CONTRACT DOCUMENTS  
BOONE COUNTY, MISSOURI  
BID #46-29JUN06 Boone Industrial Park-Road Improvement Project

**ADDENDUM #1**  
(Issued June 22, 2006)

BOONE COUNTY, MISSOURI  
 BOONE INDUSTRIAL PARK Project No. 06-375

ADD #1

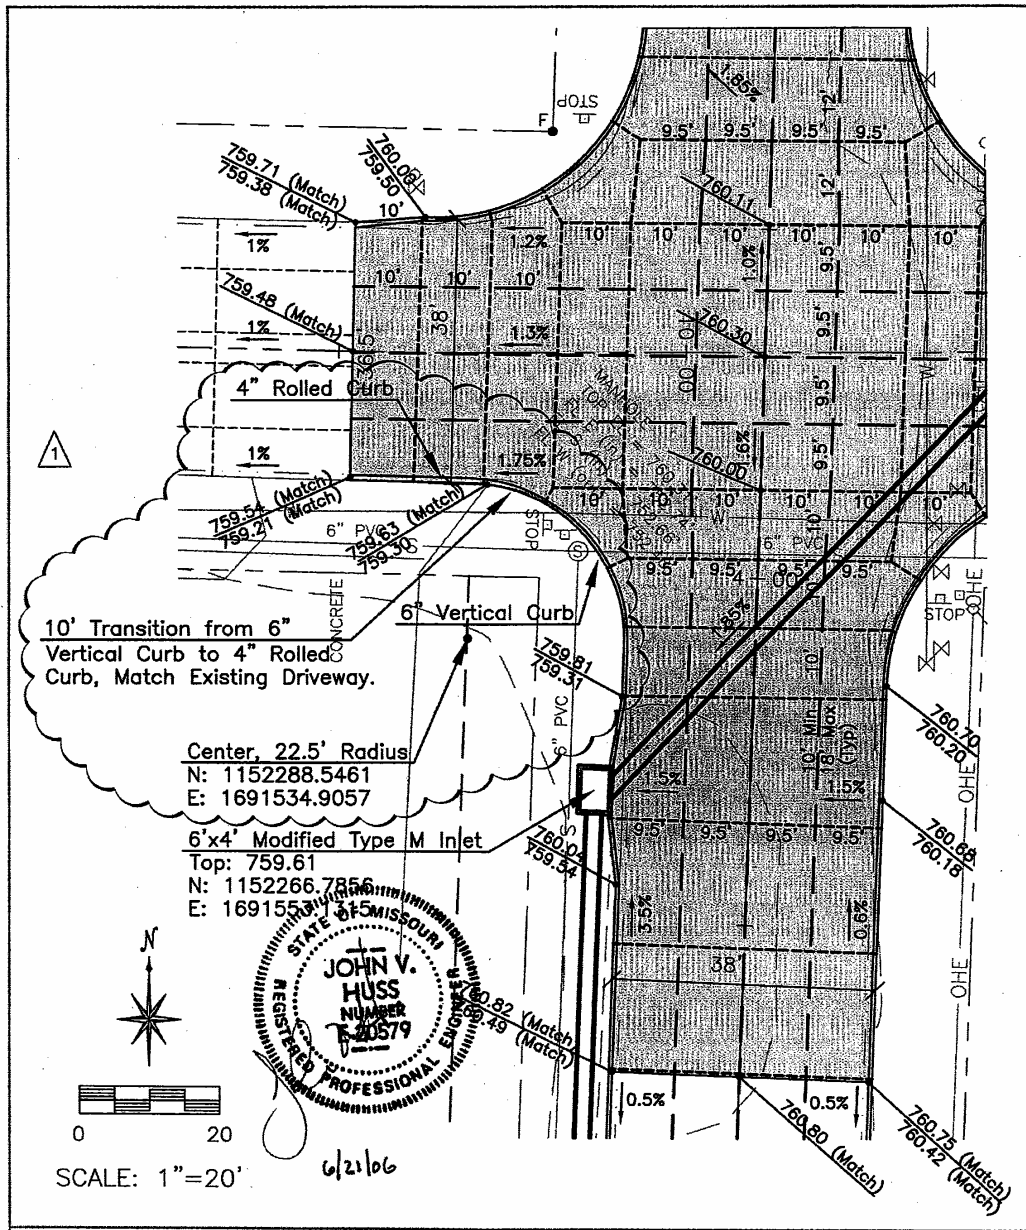
10. The attached drawing listed "ADD #1", which is part of this addendum, shows changes to the design of the southwest corner of the intersection, specifically the radius and the transition to the adjacent driveway.
